RANCHO SECO UNIT 1  
TECHNICAL SPECIFICATIONS

Proposed Amendment No. 107

## ENGINEERING CHANGE NOTICE

ECN No. A-3666 KEV

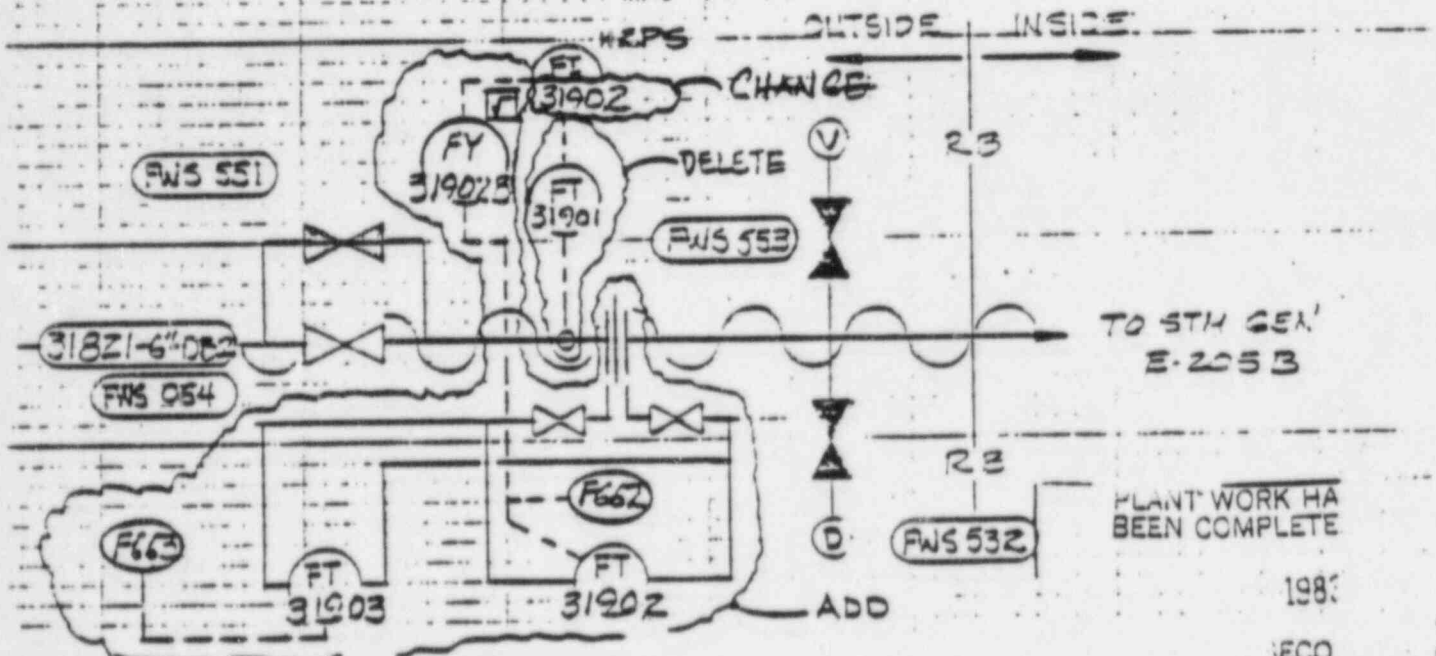
- ☒ THE FOLLOWING SYSTEM(S) WILL BE AFFECTED BY THIS CHANGE  
AUXILIARY FEEDWATER SYSTEM  
(FLOW INDICATION)

Change is required to meet the requirements  
of Reg Guide 1.97 (to monitor operation) and  
NUREG 0797, II E132C (Safety Grade Flow Indication)

This ECN includes all necessary Electrical work to complete the task.  
Estimated cost: \$70,000

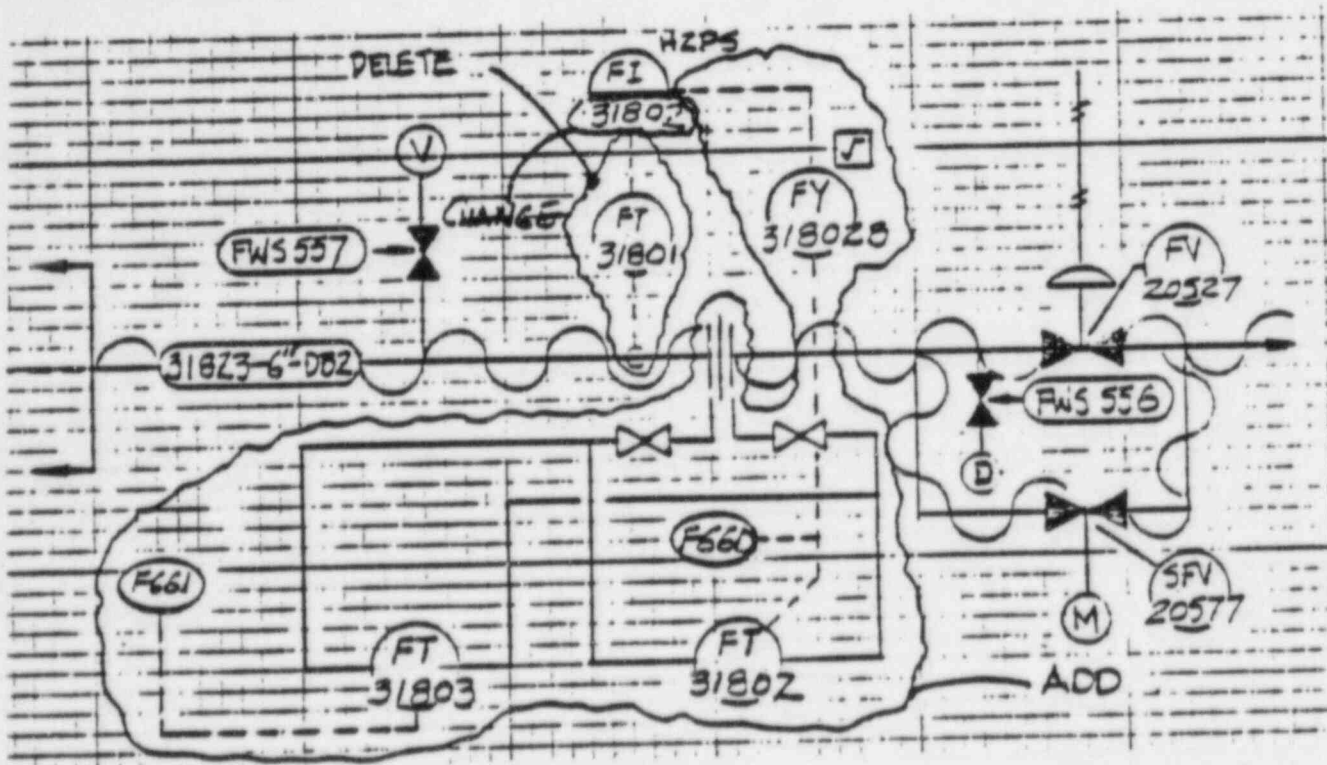
THE FOLLOWING SYSTEM(S) WILL BE AFFECTED BY THIS CHANGE  
AUXILIARY FEEDWATER SYSTEM  
(FLOW INDICATION)

REASON FOR CHANGE  
Change is required to meet the requirements  
of Reg Guide 1.97 (to monitor operation)  
and NUREG 0737 I.E.1.2.2.2 (Safety Grade Indication Flow)
